Proposal for amendments to ECE/TRANS/WP.29/GRSG/2019/33

I. Proposal

Paragraph 7.1.3.3., amend to read:

Figure 4
Determination of Zone I

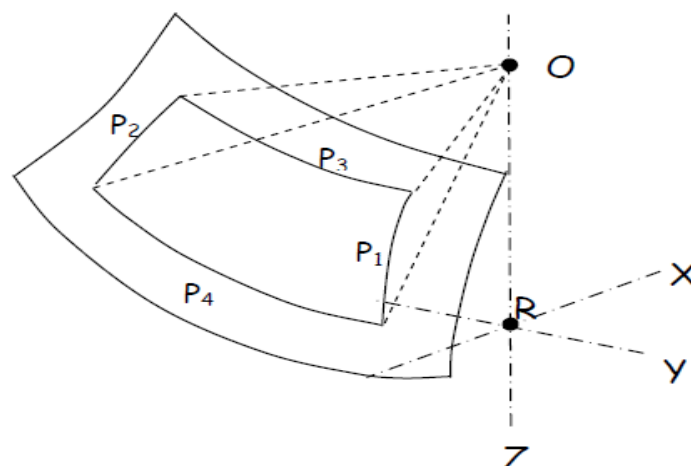
In addition, opaque obscuration can be exempted in Zone I. It is the limited areas where it is intended that a sensing device, e.g. a rain-drop detector, rear view mirror or autonomous sensors, will be bonded to the inner side of the windscreen. The opaque obscuration where such devices may be applied is defined in paragraph 7.1.3.3.3. of this annex.

P5 a plane passing through a transverse horizontal line containing O and forming an angle of 5° above the horizontal plane

P6 a vertical plane passing through O and inclined at 20° to the right of the X axis in the case of left-hand drive vehicles and to the left of the X axis in the case of right-hand drive vehicles.

P7 a plane symmetrical to P6 in relation to the longitudinal median plane of the vehicle;

Figure 4(a)

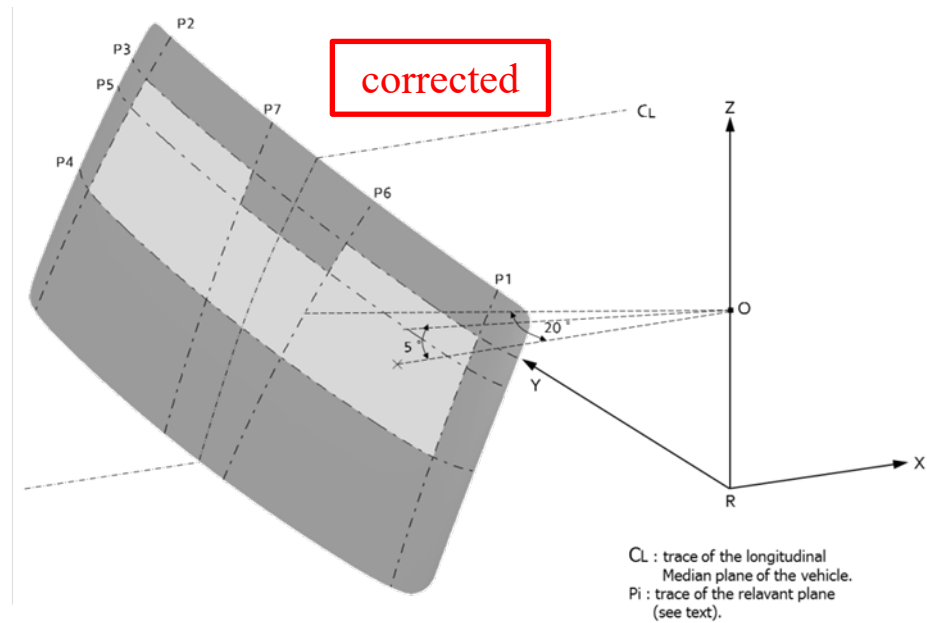
7.1.3.3.3.1. Any opaque obscuration bounded downwards by P5 and laterally by P6 and P7; (See Figure 4(a))

(Upper obscuration area as defined in paragraph 7.1.3.3.3.1.)

Figure 4(b)

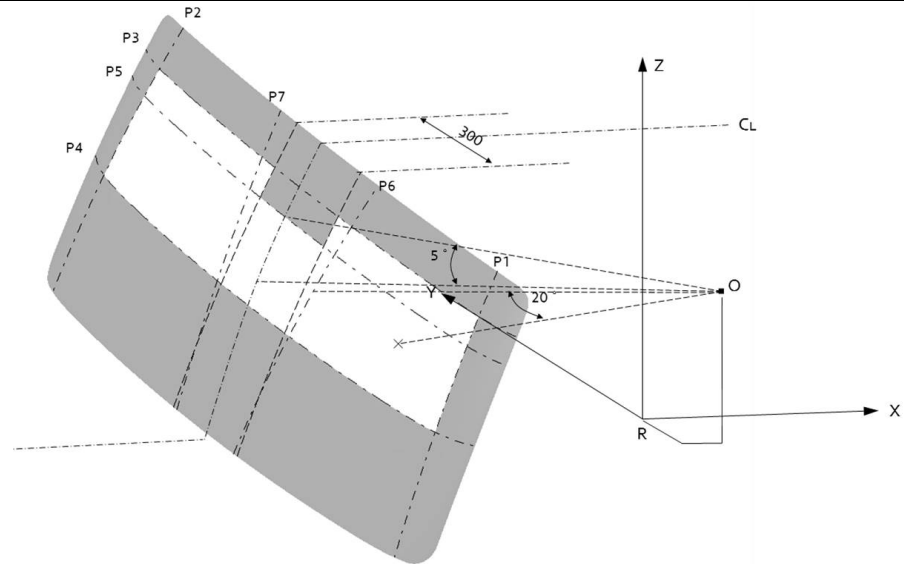
~~7.1.3.3.3.1. At the discretion of the vehicle manufacturer, one of the two following paragraphs may apply: (See Figure 4(a) or Figure 4(b))~~

~~7.1.3.3.3.1.2. Any opaque obscuration bounded downwards by P5, provided it is inscribed in an area 300 mm wide centred on the longitudinal median plane of the vehicle.~~

(Upper obscuration area as defined in paragraph 7.1.3.3.3.1.2.)
